MODEL 203, 209

P83.00-2051-05

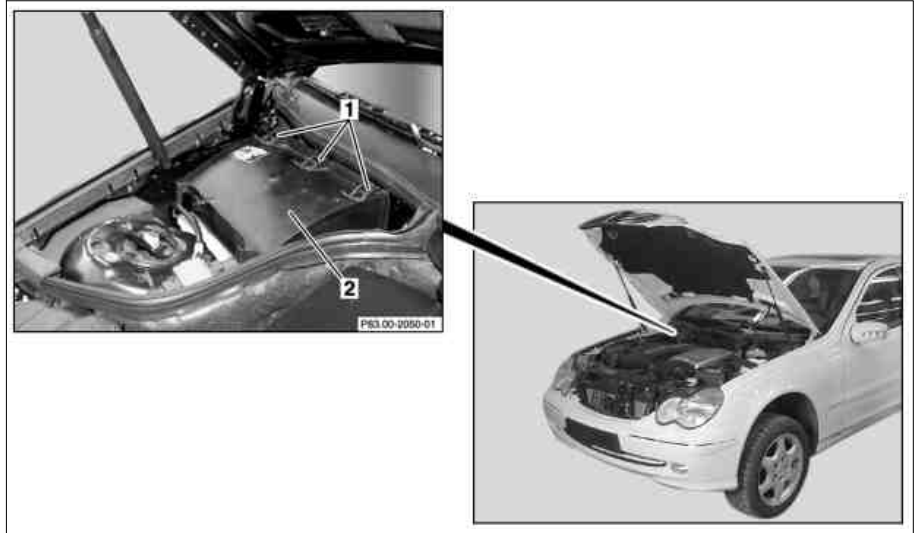
10.11.00	Slacken screw, removed	Step 2	
10.11.00	Turn bracket, removed	Step 3	
10.11.00	Picture revised	Entry picture
